January 22, 2026

Subject: Response to DEQ Comments on Work Plan
Project Number: DallasMill-1-02
Dallas Mill Properties
ECSI File #6710
1551 Southeast Lyle Street
Dallas, Oregon

DallasMill-1-02	
AOPCs with Proposed Sample Locations	
1551 SE Lyle Street, Dallas, OR	
CENTRAL ENGINEERING SERVICES	Figure 3

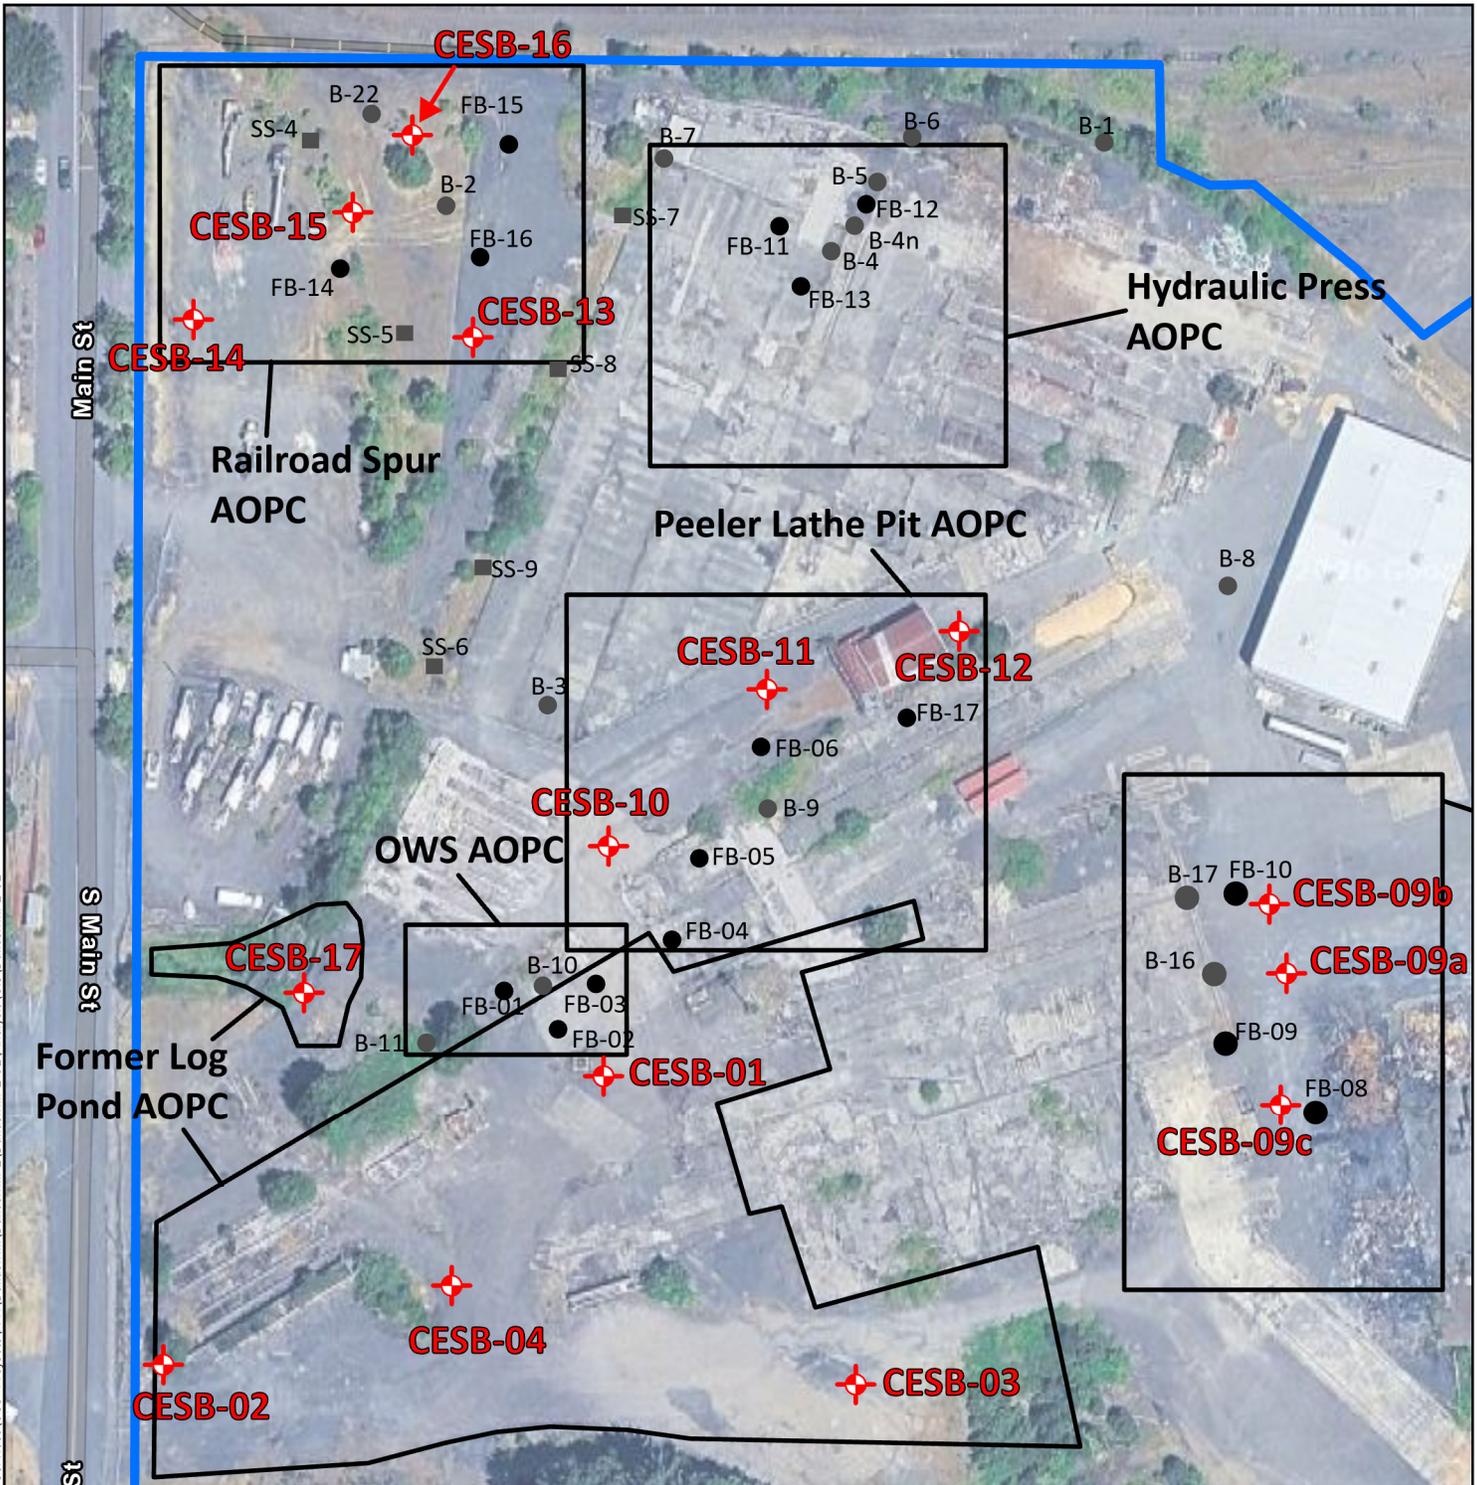
1. If the smaller log pond area on Figure 3 was also infilled, a boring should probably be added at that location.

The historical smaller pond area is in the vicinity of the present-day Ash Creek, which is primarily culverted and daylights in a few areas across the Site. Based on the aerial photographs, the area was generally a creek inlet connected to the pond. However, in some aerial photographs, the creek appeared to be wider or flooded, likely influenced by the connecting pond, and the outline in Figure 3 shows the approximate maximum extent of the inlet. Based on this information, the depth of fill material is likely limited compared to the pond and it is unlikely we would be able to identify a native pond sediment layer in the area. To characterize the limited fill material, Central proposes advancing an additional boring, CESB-17, within the footprint of the historical small log pond area as shown on Figure 3 (revised and attached to this letter), and collecting one discrete soil sample of the fill material to be analyzed for the following:

- *Diesel- and oil-range organics (DRO/ORO) by Method NWTPH-Dx;*
- *Polycyclic aromatic hydrocarbons (PAHs) by U.S. Environmental Protection Agency (EPA) Method 8270E; and*
- *Waste oil metals, to include cadmium, chromium, and lead, by EPA Method 6020B.*

The sampling depth will be determined in the field based on evidence of impacts and depth of fill material.

Figure 4

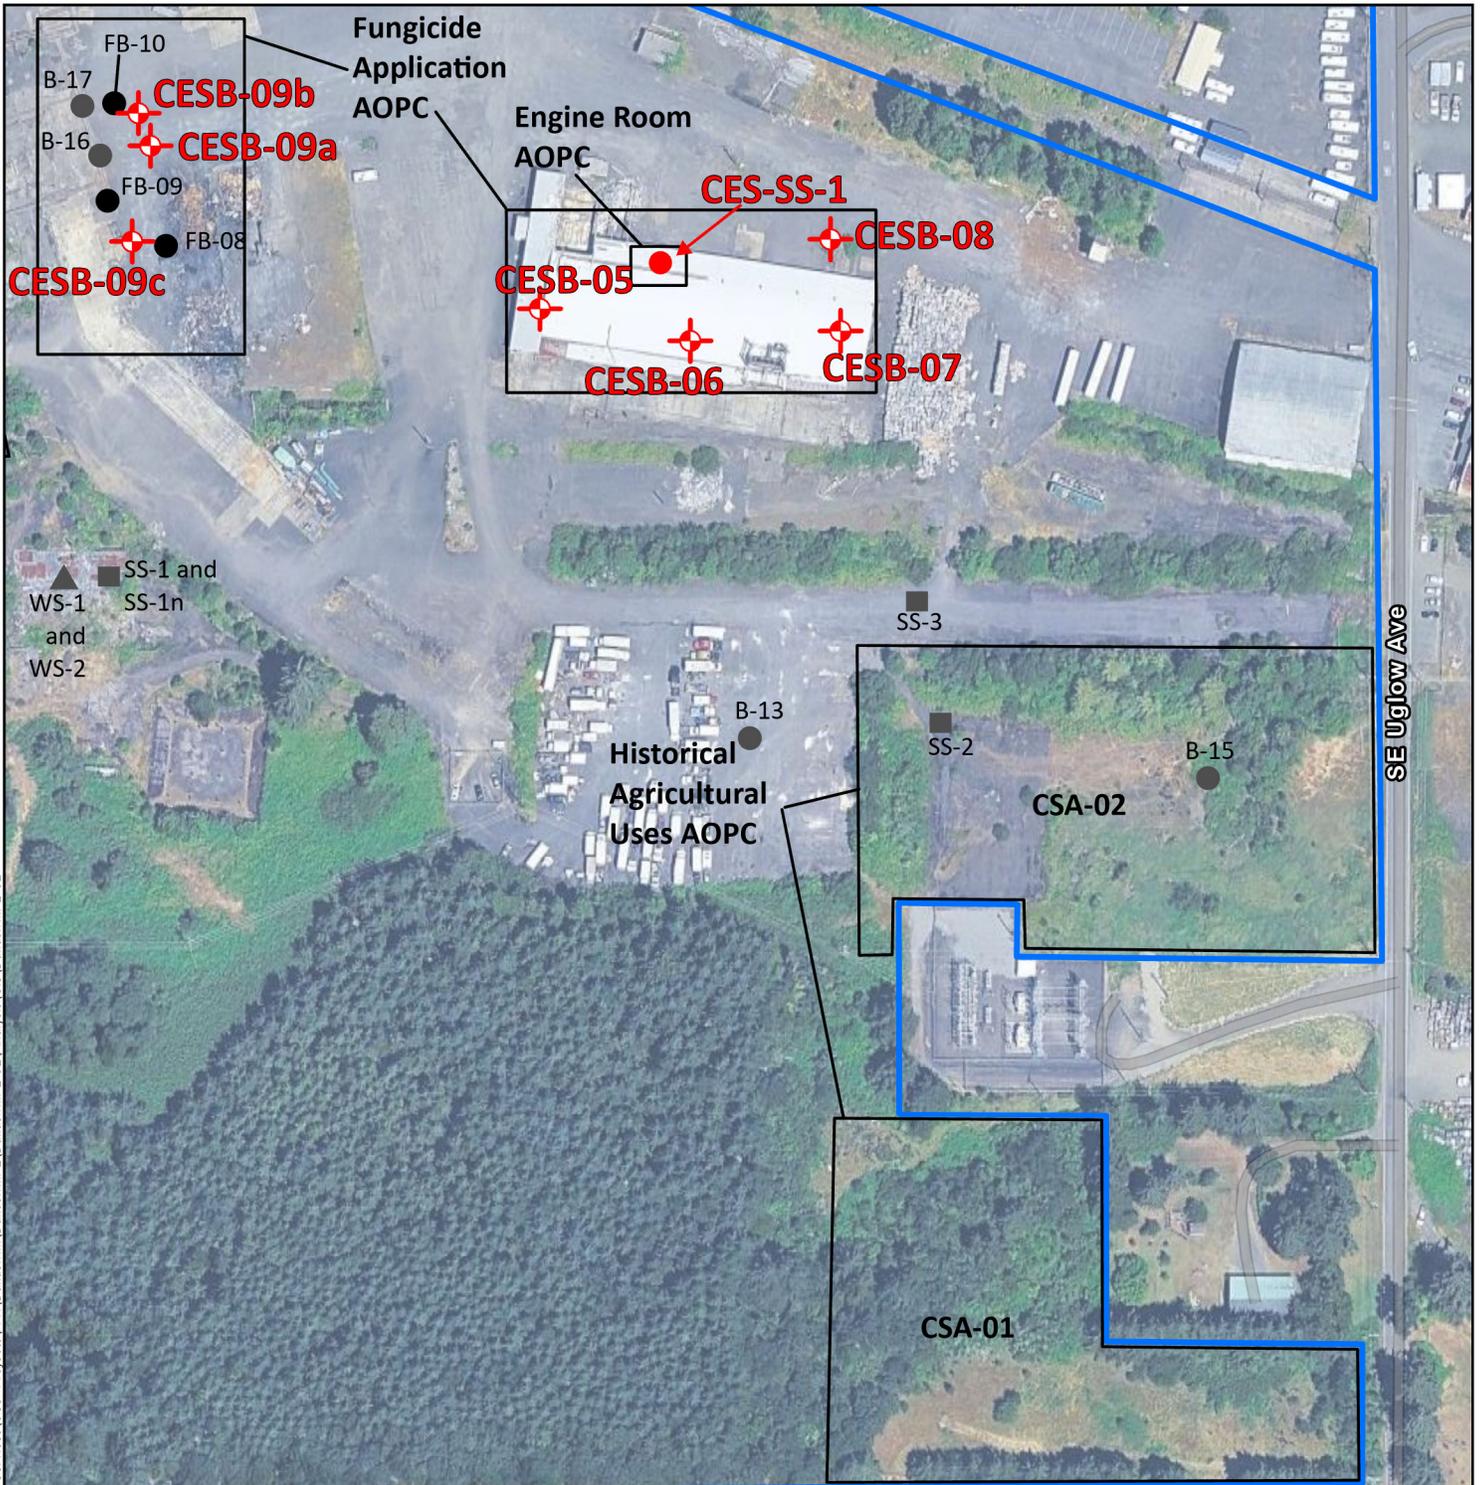
4. To cover more area, suggest adding two more sample points in the green chain area in addition to CESB-09 and collecting a composite from the three for the dioxin analysis. CESB-09 could still be used for collecting one discrete sample for penta and formaldehyde.

Three borings will be advanced along the green chain area (CESB-09a – 09c; see Figures 3 and 4) and soil samples will be collected approximately 1 foot below ground surface (bgs) or deep enough to collect the top 6 inches of recoverable soil. Soil from all three borings will be composited into one sample and analyzed for dioxins and furans by EPA Method 1613.

A discrete sample will be collected from CESB-09a and analyzed for:

- *Pentachlorophenol by EPA Method 8270E;*
- *Propiconazole by EPA Method 8321; and*
- *Formaldehyde by EPA Method 8315A.*
